**Request for Additional Information
Revalidation Review
Docket No. 71-3090
Model No. LEUPA**

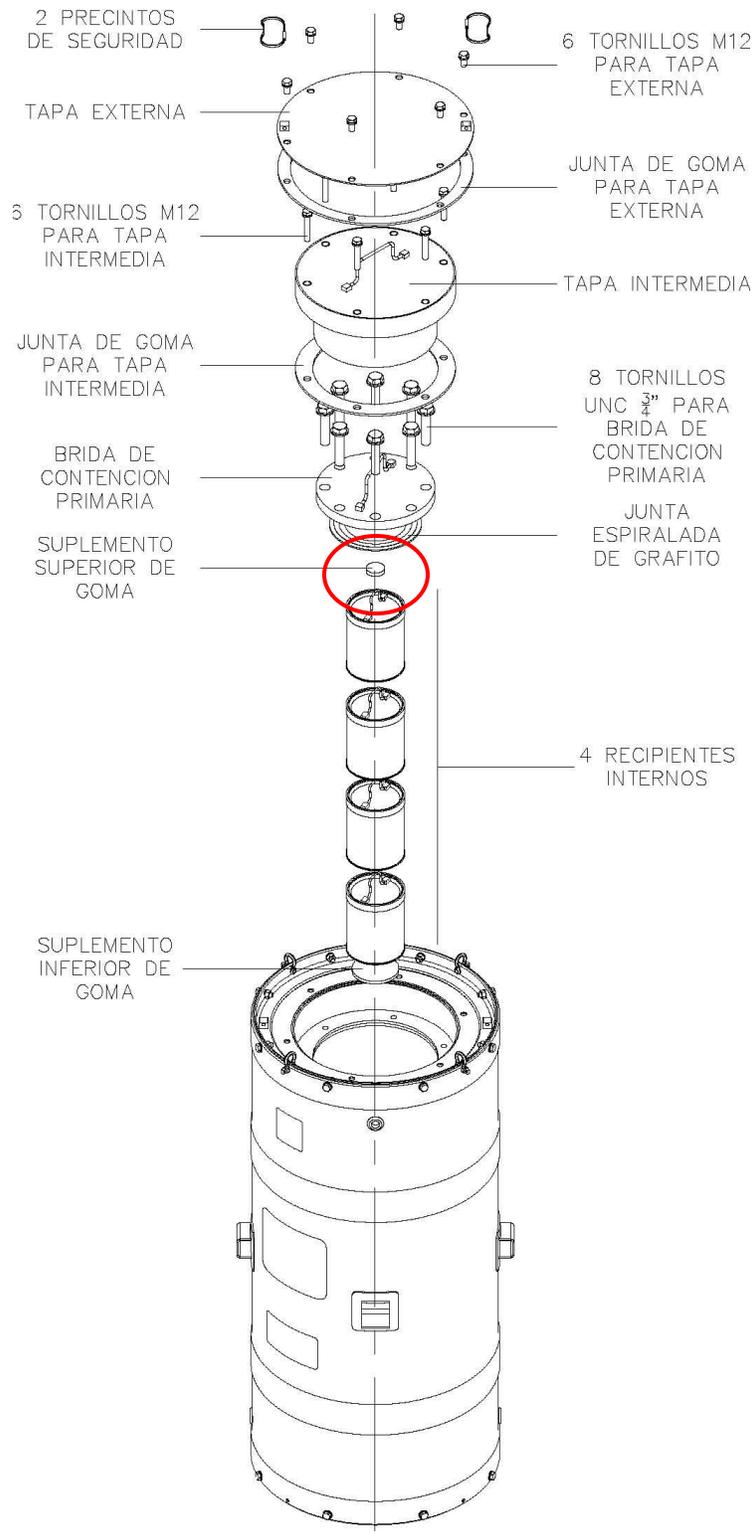
G-Sh-1. Clarify and revise, as needed, in the application the description of the Primary Containment Lid/Flange.

Based on Drawing No. 0908-LE01-3ASIN-005, this component is a solid lid with a solid section of cadmium in its center on the bottom side. However, Picture 27 of the "Tests Final Report" document identifies a steel disc with a large central hole as the primary containment lid/flange. This is not consistent with the design shown in the technical drawings.

Picture 27 of the "Tests final report" displays in its lower part of the main cover the rubber upper supplement; the supplement is attached to the cover.

This component conforms to drawing 0908-LE01-3AEIN-005.

The following image in the next page, displays an assembly of these components.

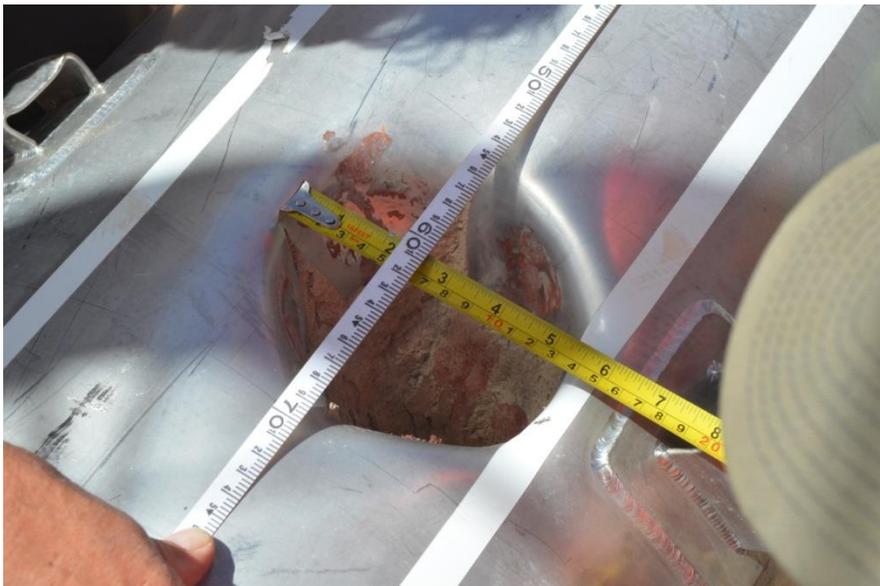
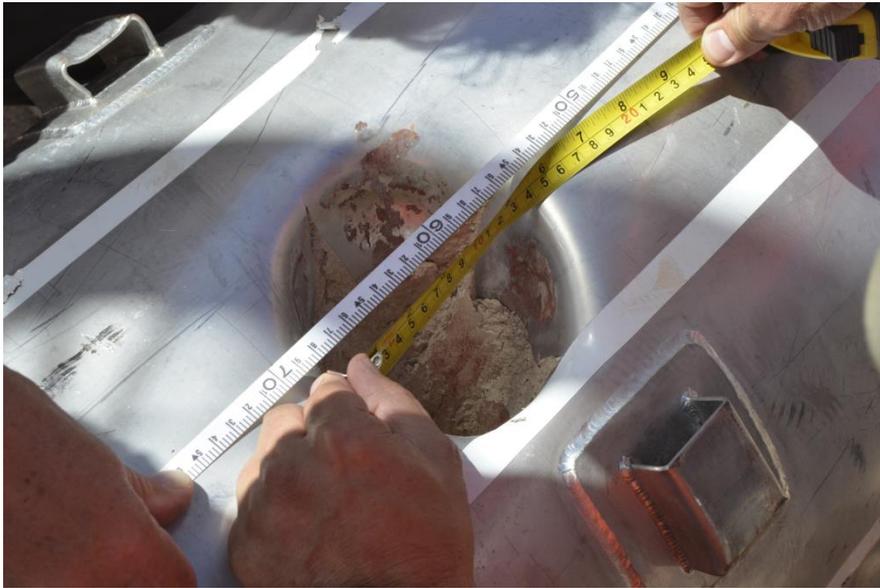
- St-2.** Provide justification for the applicant's statement that the Model No. LEUPA package will prevent the entry of a 10-centimeter (cm) cube after being subjected to tests specified in paragraphs 719 to 724.

The applicant does not provide sufficient information in Document Nos. 0908-LE00-3BSIN-023A and 0908-LE02-3BSIN-002A to justify how the applicant meets the requirements in paragraph 675².

The only test which produces an opening in the external hull is the penetration test. Document 0908-LE02-3BEIN-008-A - TEST FINAL REPORT shows in figures 19 and 18 the test and its results approved by the Nuclear Regulatory Authority issuing the certificate, present during the test.

Below are more pictures of the results, where we see the maximum penetration diameter is 14 cm and decreases towards the inside, which means it would not fit a 10 cm side cube.
